3.4 Instrumentation and Control

STD DEP T1 3.4-1 (Figure 3.4a, Figure 3.4b, Figure 3.4c)

Figure 3.4a Safety System Logic and Control (SSLC) Control Interface Diagram

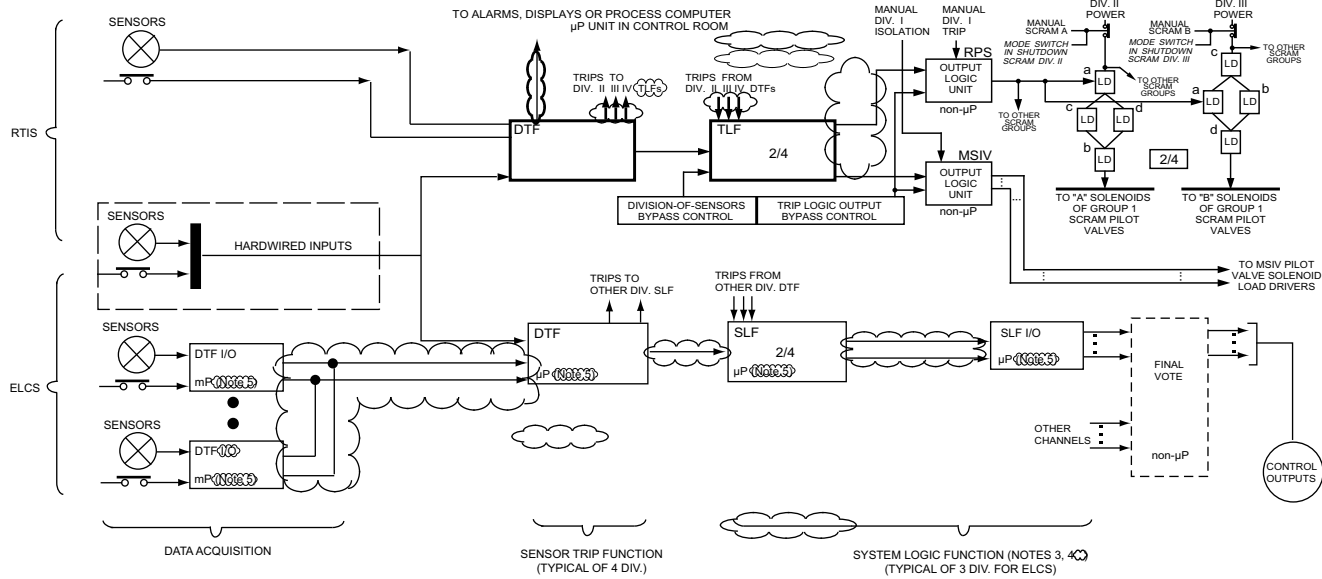
safety-related portions of the Neutron Monitoring System (NMS), the Containment Atmospheric Monitoring System (CAMS) and the radiation monitoring systems. The relationship between SSLC and systems for plant protection is shown in Figure 3.4a.

Figure 3.4b Safety System Logic & Control Block Diagram

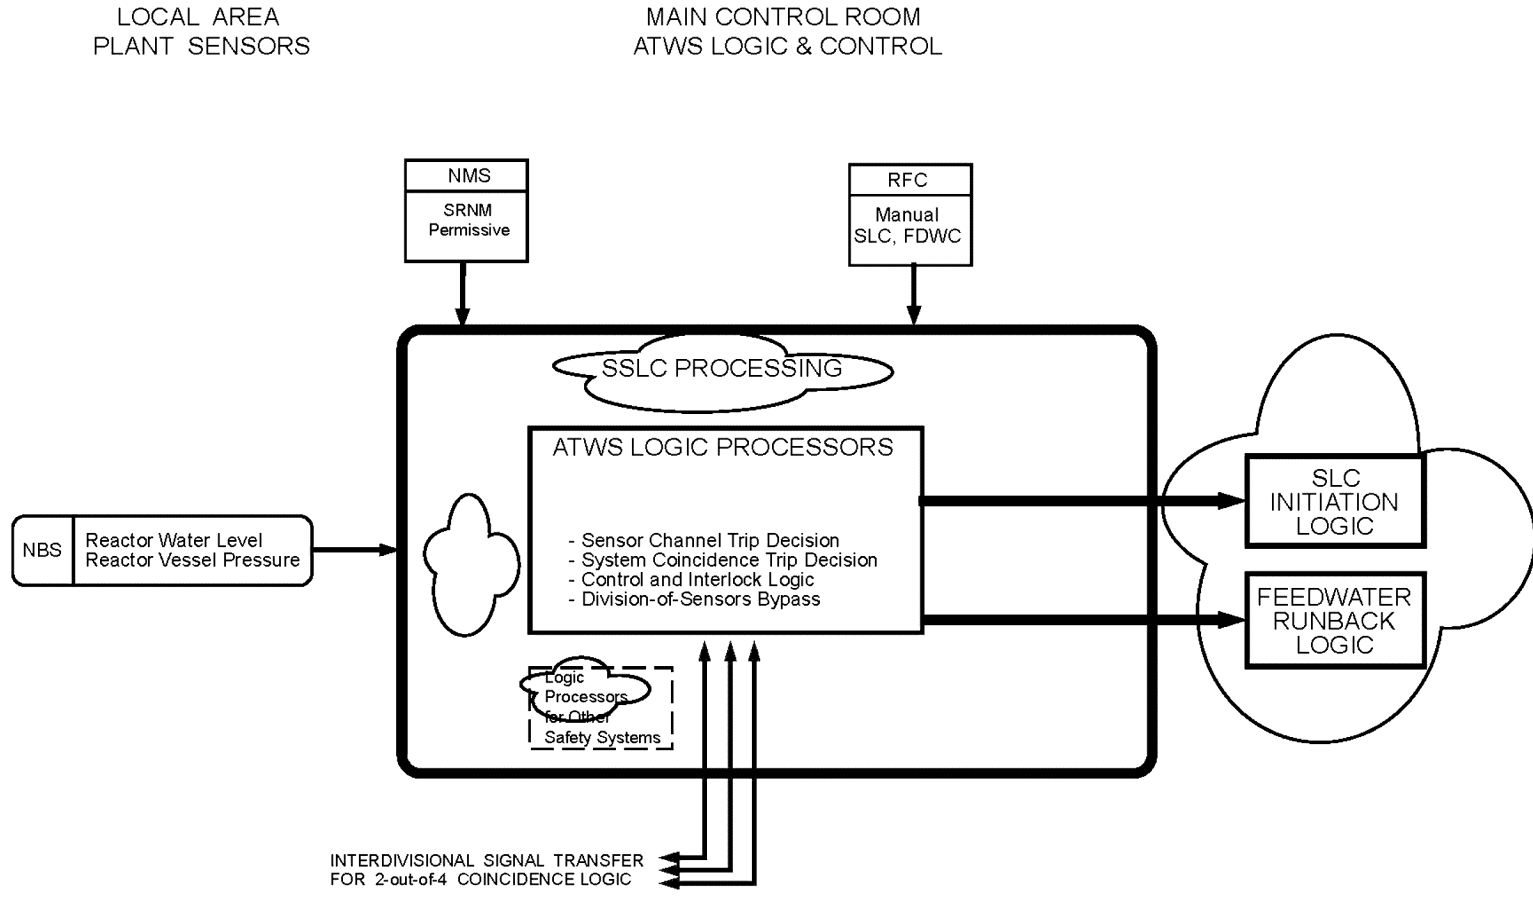
~~The basic hardware functional configuration for one division of SSLC is shown in Figure 3.4b. Each division runs independently (i.e., asynchronously) with respect to the other divisions. The following steps describe the processing sequence and associated function descriptions for incoming sensor signals and outgoing control signals. These steps are performed simultaneously and independently in each of the four divisions:~~
